UNITED STATES PATENT AND TRADEMARK OFFICE

Office Action Summary

10/800,299

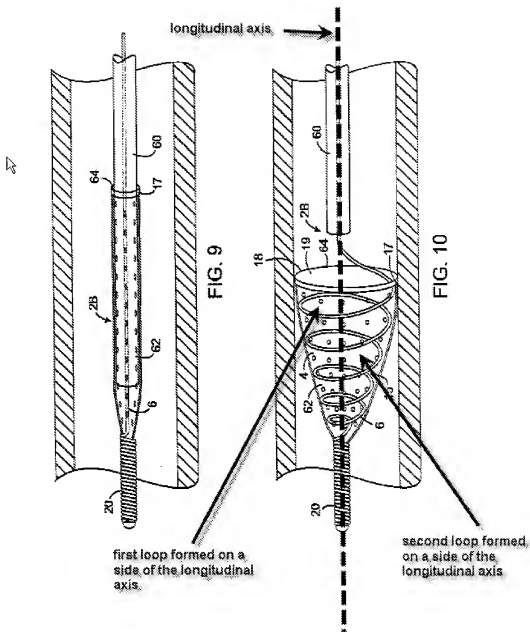
As seen in Fig. 9 and 10, Dieck discloses a distal protection device comprising a catheter **60**, a flexible member **6** positioned and movable from a first position (Fig. 9) to a second looped position (Fig. 10) extending laterally with respect to the catheter, such that in the second looped position a loop opening is formed lying in a plane that is non-aligned with a longitudinal axis of the catheter (Fig. 1), the flexible member being movable between the first and second

positions by user control by movement of the flexible member 6, and self-retracting filter material 4 movable from a an original collapsed position (Fig. 9) to an expanded position (Fig. 10) in response to movement of the flexible member, wherein the filter material automatically moves from the expanded position back to the original collapsed position upon movement of the flexible member back to the first position, in the first position, at least a portion of the flexible member is retracted within the catheter and unexposed, and in the expanded position the filtering material allowing blood therethrough while being capable of capturing material dislodged by a treatment device; wherein the catheter has an opening in a sidewall (the distal end wall) through which the flexible member extends when moved to the second looped position; wherein in the second looped position, a separate loop opening is formed on each side of the longitudinal axis (see attached figure below).

7. Applicant's arguments filed 6/5/08 have been fully considered but they are not persuasive. The applicant amended claim 15 to recite that the flexible members form separate loop opening on each side of the longitudinal axis. However, as shown in the attached figure above, Dieck discloses loop members that can be viewed as being separated by the longitudinal axis.
